FORCE Outboards

service bulletin

No. 92-13

Stator (P/N F616095)

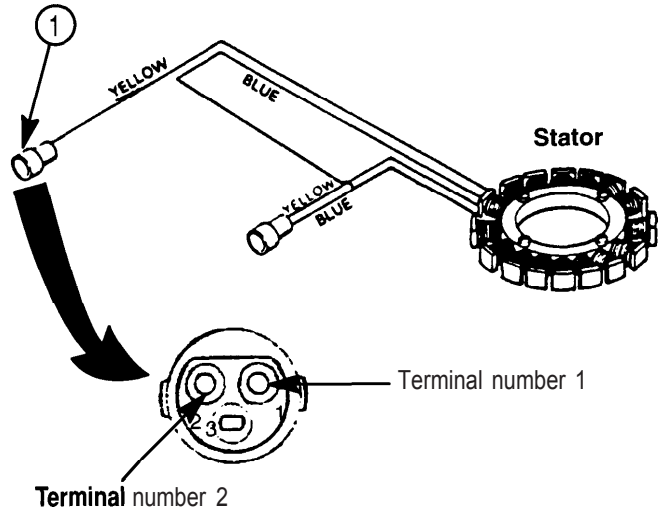
No spark on No. 3 cylinder after installation of replacement stator (Part Number F616095).

Inspect the wire and pin at the back of the plug (1) on the connector from stator. The yellow wire should be connected to the pin at terminal number2 of plug (1). The terminals are marked. If the wire goes to the pin at terminal number 1, stator must be replaced.

If there are any F616095 stators in your inventory, please inspect them. If any are found to be defective, contact your distribution center for exchanges.
